**Rainbow Child Care Center**  
**3055 N Ankeny Blvd**

*Plan and Zoning Commission  
Staff Report*

**Agenda Item:** 3055 N. Ankeny Blvd. – Rainbow Child Care Center Site Plan  
**Report Date:** November 2, 2017  
**Prepared by:** Eric Carstens, AICP  
Planning Administrator

(1) 6' X 7' ILLUMINATED D/F MONUMENT SIGN  
SCALE 1/2" = 1'  
RAL MS-611A X 75H-070164

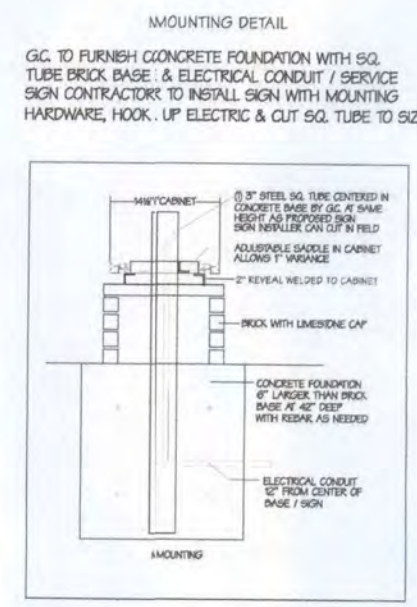
A potential yard sign location has been shown on the site plan and Sheet 6 includes a design for a possible sign. Final design and allowances will be determined with future sign permits.
